ADDENDUM

Project: Des Plaines Public Library Library Renovation Project Addendum No. **01**

Project No: 13300 Date: 03 September 2015

REQUEST FOR INFORMATION (RFI) RESPONSE

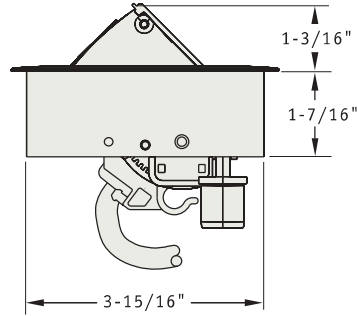
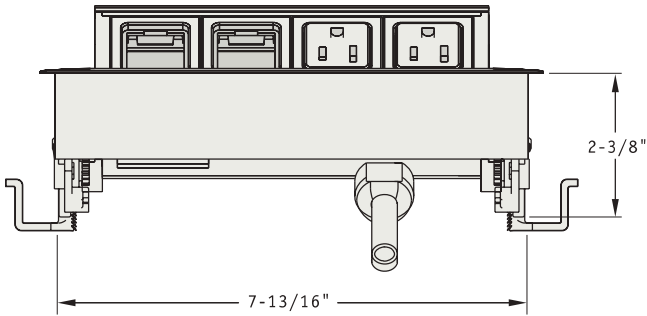
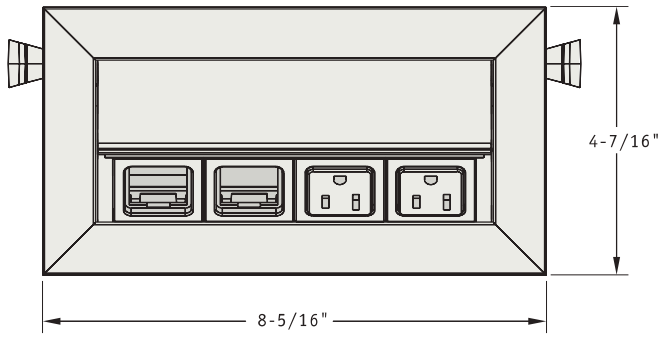
2. **Question:** On the drawings for the E Bars you state you want power boxes with Power, Data, and AV. Here is our recommendation:
 - Byrne MHO Power Box
See attached document. (Included)
 - This unit is 4"W. It would be 8"L with 4 Ports or 9.5"L with 5 Ports. Please review and tell me how many of each of the following you want:
 - Power Outlets
Data Jacks (library IT will add their data to port)
HDMI
 - Specify Black or Silver for the Box.
 - The power box is mounted in the table top. It pops up when in use. It closes with a cover, sitting flush on the table.
 - I do not see power needs on the Information Desks. If you need power for the desks, please indicate what you are looking for.

Answer: At the E-bar, the recommended Byrne MHO Power Box is an acceptable solution. The Library has decided that they would like Power only at each port location indicated in plan. A total of (8) MHO Power boxes – with 4 power plugins at each. A metal grommet should be located as indicated in plan at the east side of (2)

of the counter height E-bar tables to provide access to a floor core that will service the TV at each of these locations.

Finish – Silver

The information desks do not have desktop power/data requirements. They have a grommet at each seated location, as shown in plan, where they will be serviced by the floor box below the desk.

Refer to the revised Electrical plans as part of Addendum #1.

1 1ST FLOOR POWER PLAN - NEW
 SCALE: 1/8" = 1'-0"

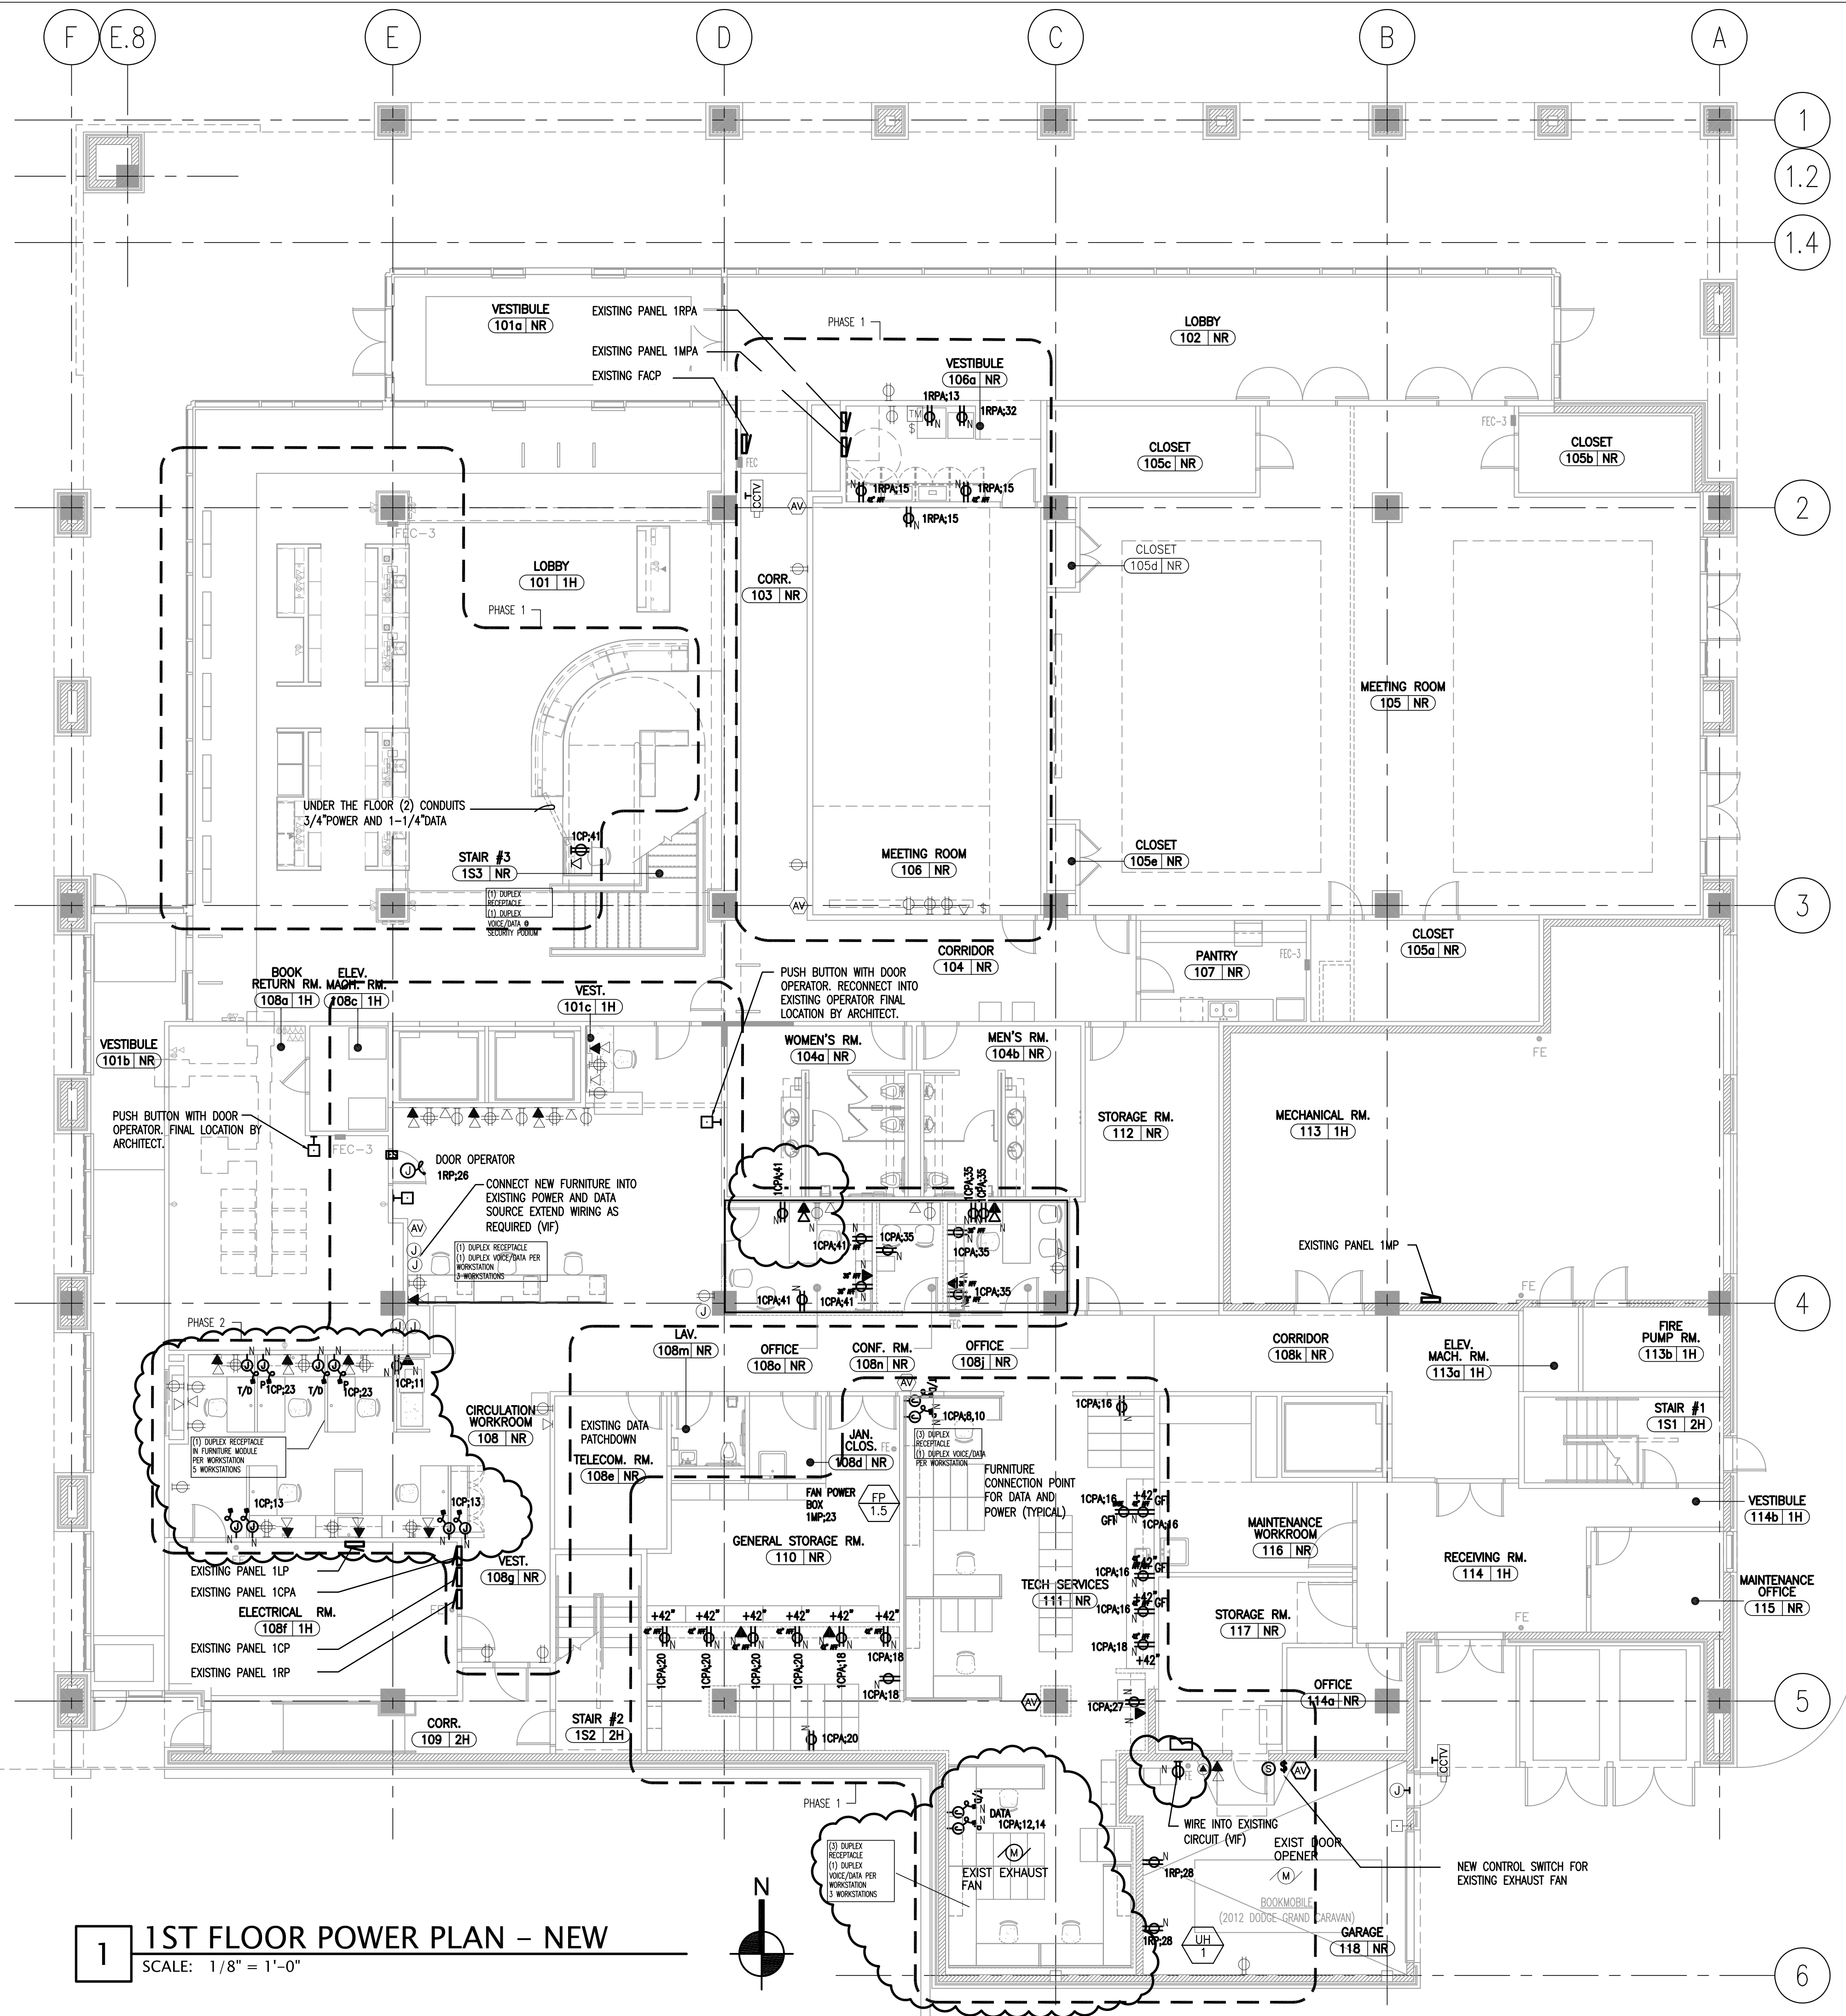
4. **Question:** What does the dark triangle represent? Is this a wall phone, if not please clarify this is not on symbol list. It appears on drawing E1.1 rooms 108, 110, 111, 108o, 108j.

Answer: Yes, Refer to the revised Electrical plans as part of Addendum #1.
10. **Question:** On drawing E1.1 room 110c are we just installing new (3) workstations per note? And locations toward the top are existing to remain, is this correct?

Answer: The "dark triangle" represents a single Data connection
Refer to the revised Electrical plans as part of Addendum #1.
5. **Question:** What does the clear triangle represent? Is this a single data, please clarify again not on symbol list.

Answer: We are assuming you are referencing **101c**. Yes, the locations on the north wall are existing to remain. All new devices are shown "bold", existing devices are "half-tone" See revised E1.1 sheet for clarification

1. Electrical Review *New or re-used receptacles shall conform to NEC 2011 Section 406.14*

Response note on sheet ED1.1. It should be determined by the Library where if any Child Care Facilities are in this Project:

ELECTRICAL PERMIT NOTES		
1	NEW AND RE-USED POWER RECEPTACLES	NEW AND RE-USED POWER RECEPTACLES SHALL CONFORM TO NEC 2011, SECTION 406.14.
2	SECTION 406.14, TAMPER-RESISTANT RECEPTACLES IN CHILD CARE FACILITIES:	TAMPER-RESISTANT RECEPTACLES ARE REQUIRED IN ALL CHILD CARE FACILITIES. SECTION 406.2 DEFINES A CHILDCARE FACILITY AS A LOCATION WHERE EDUCATION, SUPERVISION, OR PERSONAL CARE SERVICES ARE PROVIDED FOR MORE THAN FOUR CHILDREN UNDER THE AGE OF 7.

2ND FLOOR
 POWER
 PLAN - NEW

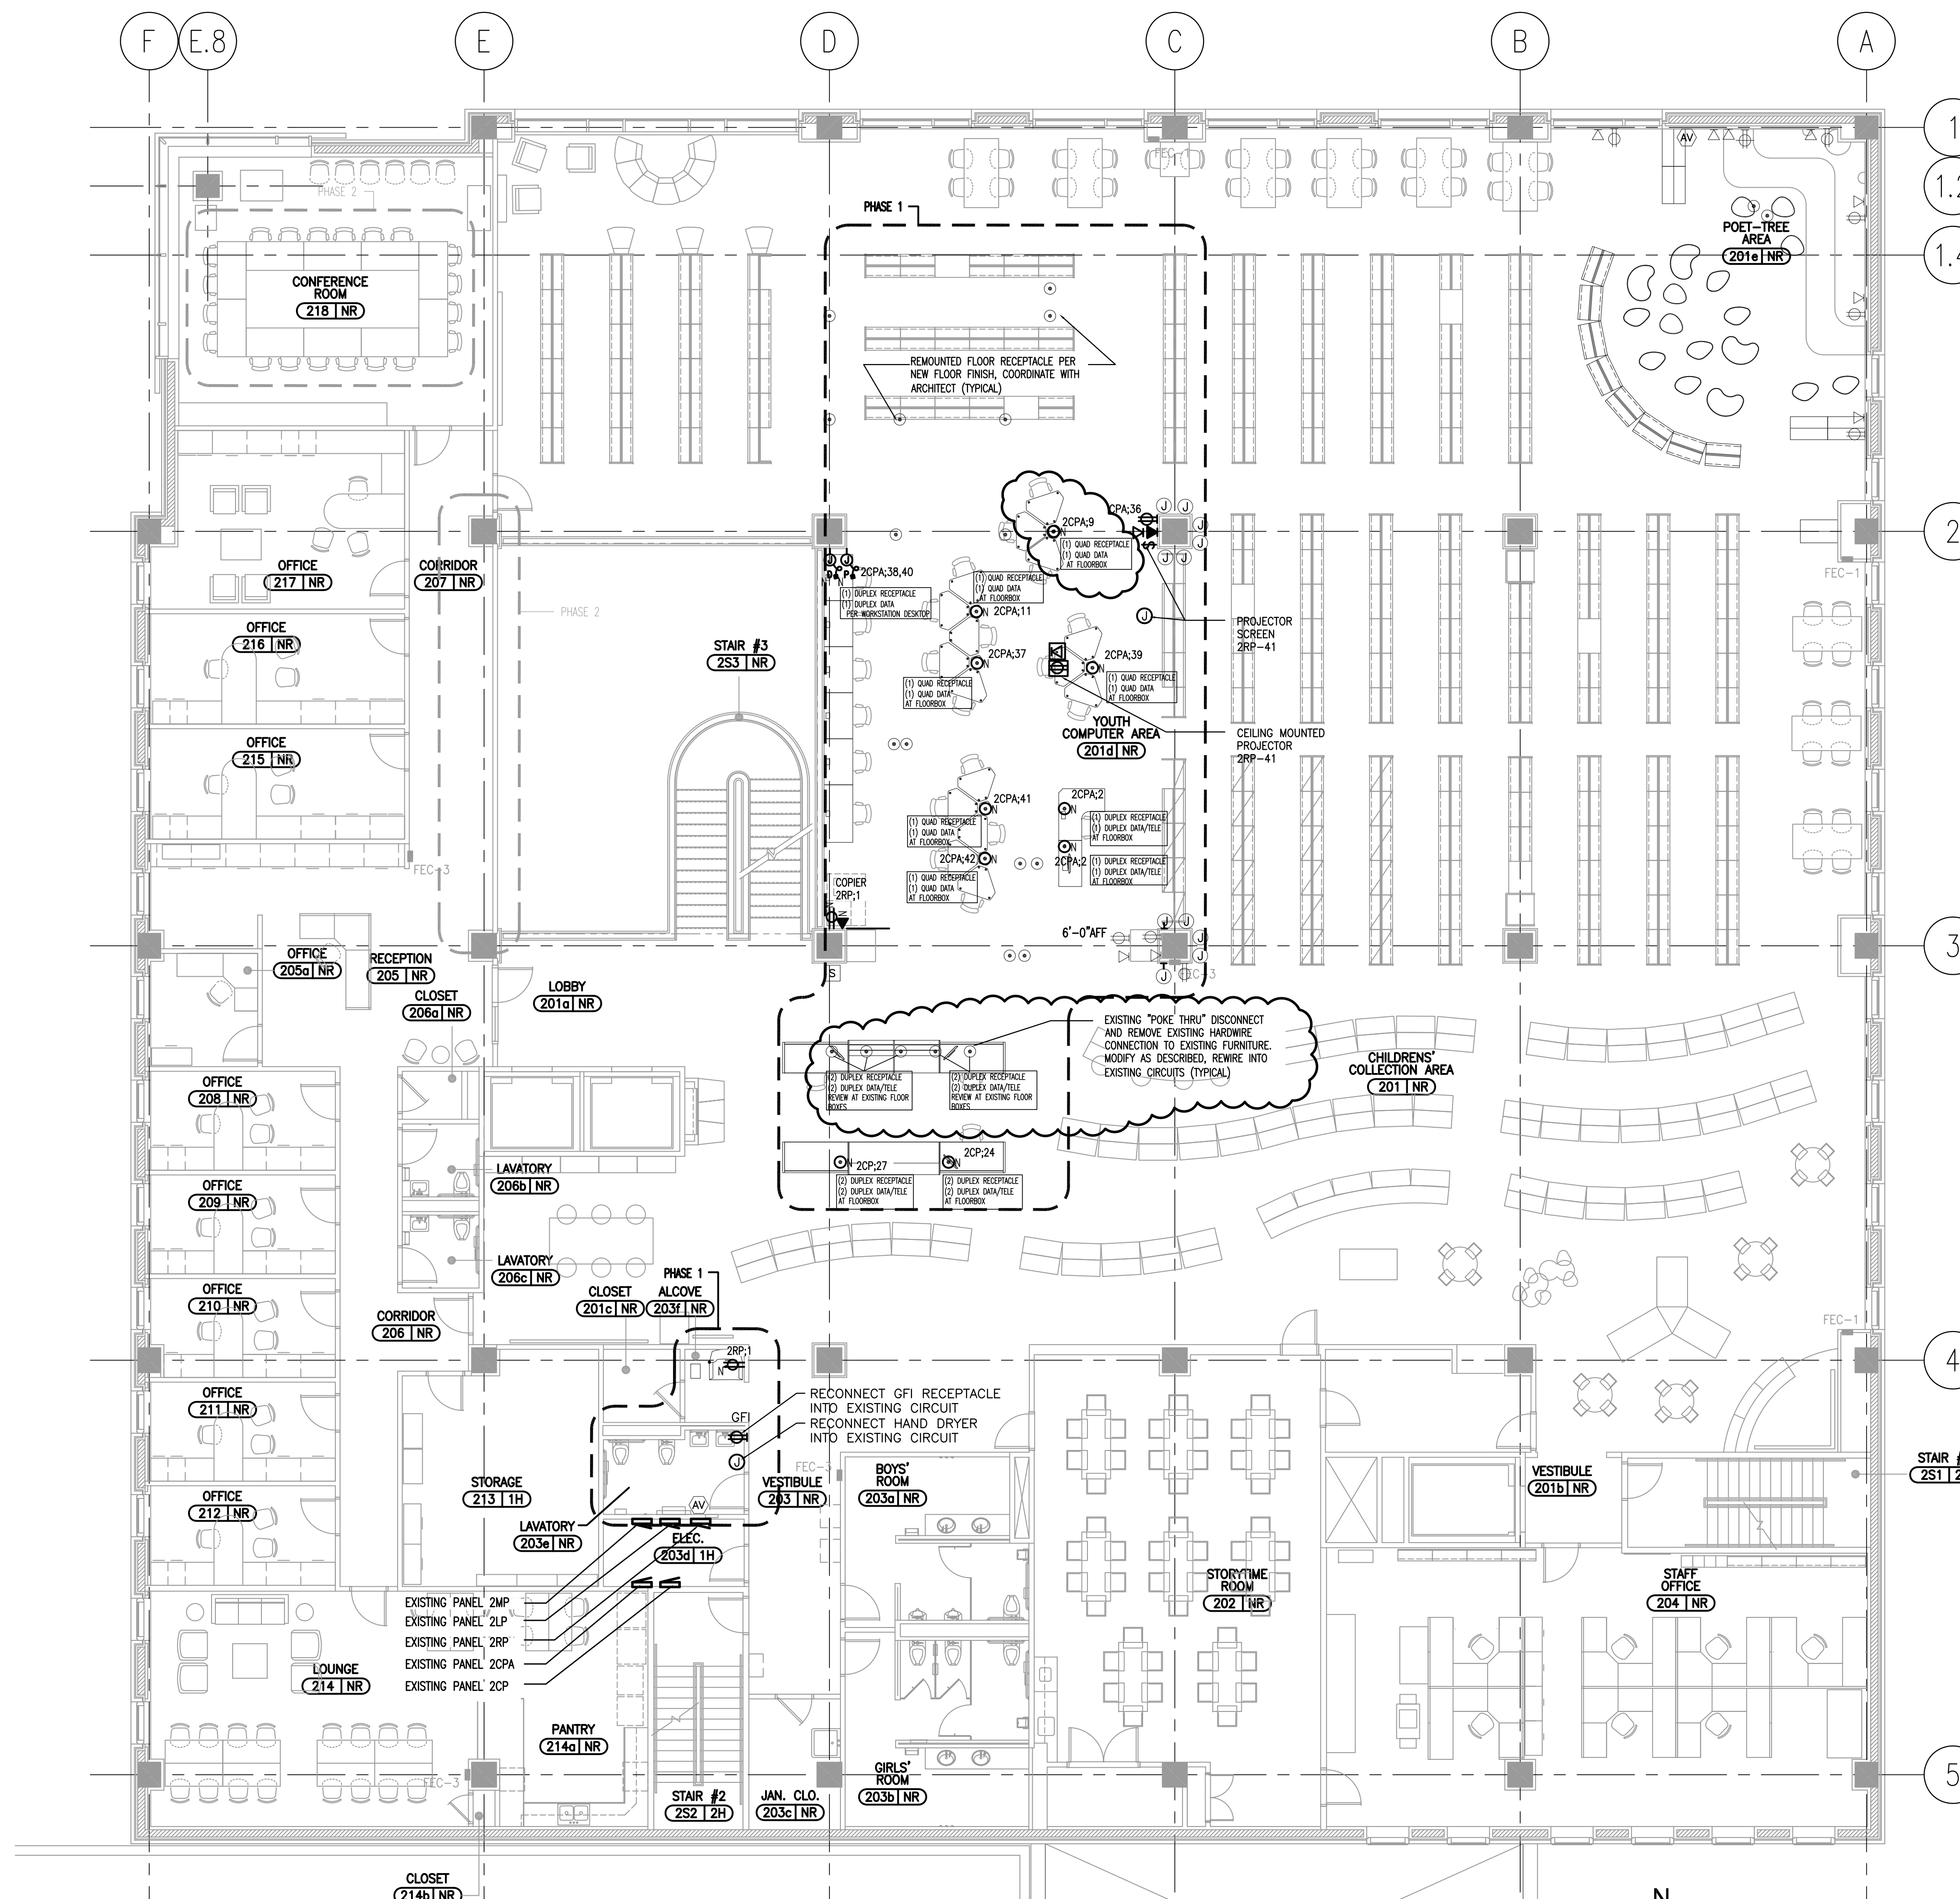
11. **Question:** On drawing E1.2 room 201d are we just installing new cabling to floor boxes with notes? And all other floor boxes without notes are existing to remain is this correct?

Answer: Correct, Refer to the revised Electrical plans as part of Addendum #1. all new devices are shown "bold", existing devices are "half-tone. Some existing devices may need to be replace or modified as noted
